CUMBERLAND
CITY COUNCIL

Ref: OA2021/0006

Subject: Request for comments-State Significant Development (SSD)
Application No: OA2021/0006
Property: 14 & 16 Kiara Crescent YENNORA NSW 2161
Proposal: Ministerial Consent - Yennora Liquid Waste Treatment Plant (SSD-10407)

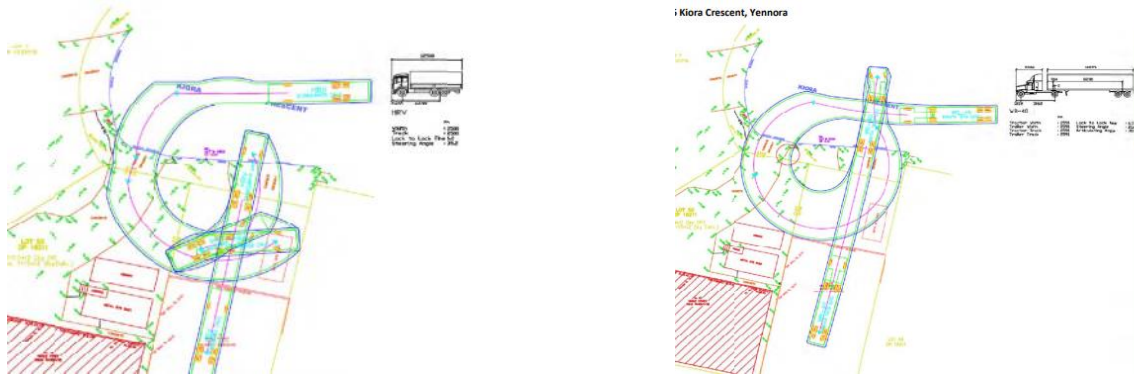
- d) Council will not support the proposed driveway widening. Driveways are provided for the site access only. All the turning manoeuvring shall be provided within the site. A separate approval shall be obtained from Council's Engineering section for any modification to the driveway. Swept path analysis submitted as part of the RTS clearly shows that the driveway widening is required for the reverse manoeuvring. Sketch from the RTS has been provided for reference:
